SB, Hardware Changes, K 7000 all variants, 2025-03

SYMPTOM/DESCRIPTION

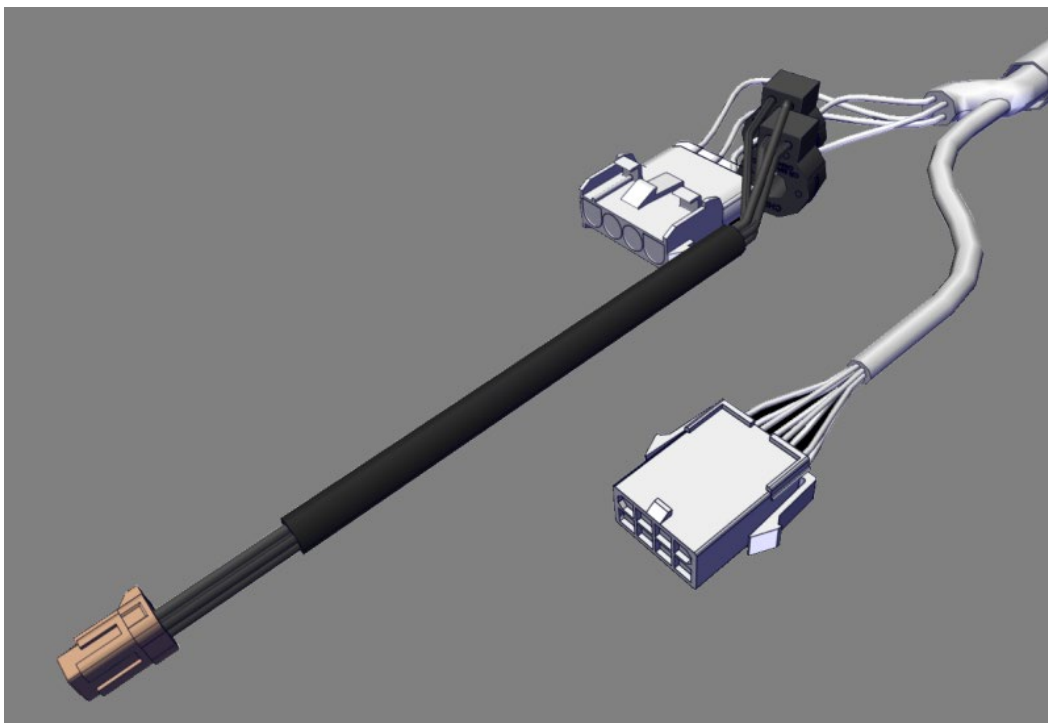
The hardware changes are two current transformers situated on the two of the motor phases, and one additional connector in the display of the K7000. Please refer to highlighted parts in the picture below.
